HARTING Product Change Notification

Product range: Inducom

Change to Some D-Sub Hoods

PCN/21/008/C+N/US

(the pictures show a side view of the 9-pole hood)

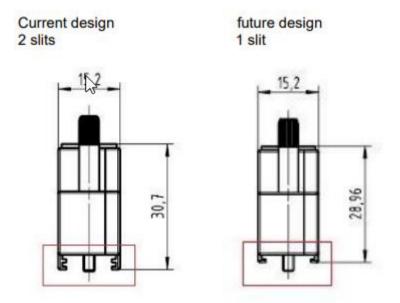
At the end of 2019 HARTING changed the design of some D-Sub Hoods. At the outer side of the hoods a 2nd slit was added (see picture below). This slit was intended for use with a mechanical coding option to be launched in the future. Please be informed, that HARTING will eliminate this 2nd slit. With this change the overall length of the hoods will be reduced to the same dimension as the pre-2019 design

The functional characteristics will remain unchanged and the new generation will be backward compatible with the today's versions.
